National Highways Planning Response (NHPR 25-01) Formal Recommendation to an Application for Planning Permission

Council's Reference: DM/23/2866

Location: Land East of Ansty Way, Cuckfield Bypass, Cuckfield, West Sussex

National Highways Ref: NH/23/04120

Figure 3 : A272 Cowfold Road / London Road – proposed roundabout

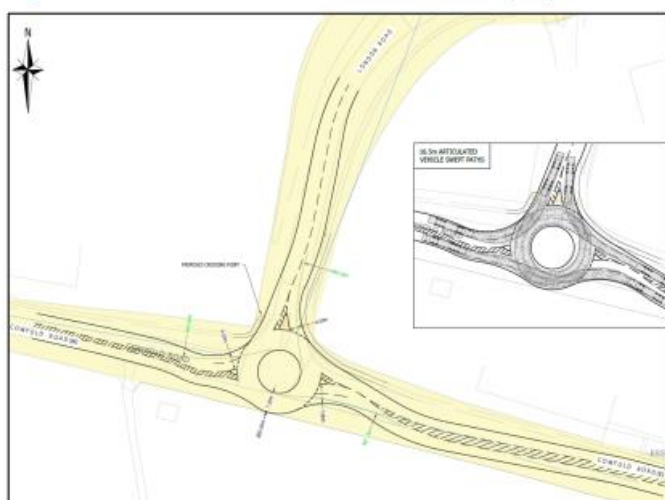
While there is no requirement for mitigation, we acknowledge that the applicant has proposed a roundabout mitigation option at this location. The proposed roundabout at A272 Cowfold Road / London Road is shown in Figure 3. We have investigated the SRN boundary based on the information we have to hand and it is seen that the London Road arm is entirely within the SRN boundary, this is contrary to TTN10 which states that the junction is not within the SRN boundary.

Whilst the proposed scheme does provide a clear betterment, as per paragraph 24 above, we are of the view that in policy terms there is no requirement for the scheme. Therefore, to be clear National Highways do not require the junction to be modified as proposed. We also understand that it is not a requirement of West Sussex County Highways either.

Figure 4 : SRN Boundary

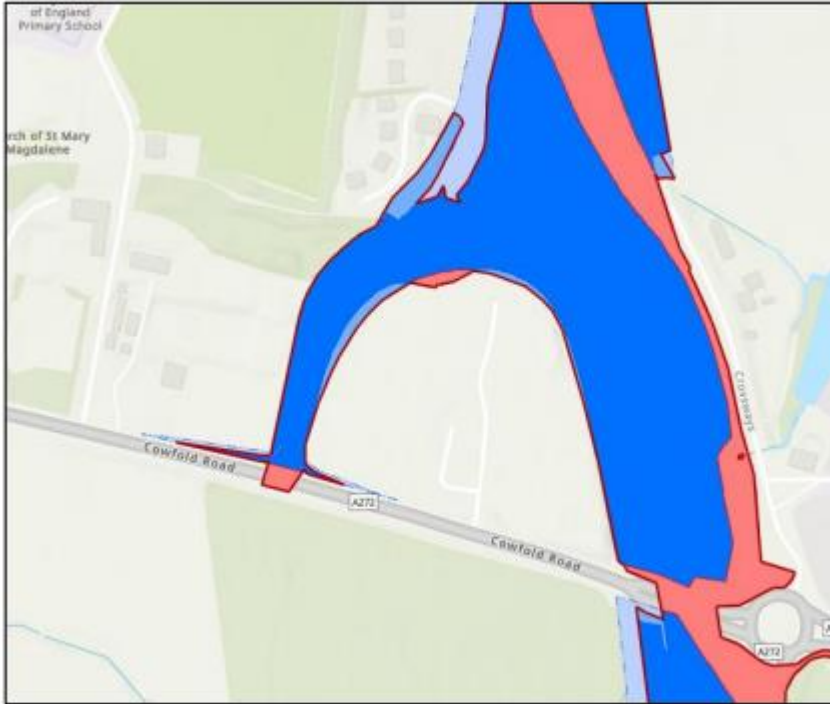
The SRN boundary, based on the information we have to hand, at this location is shown in Figure 4.
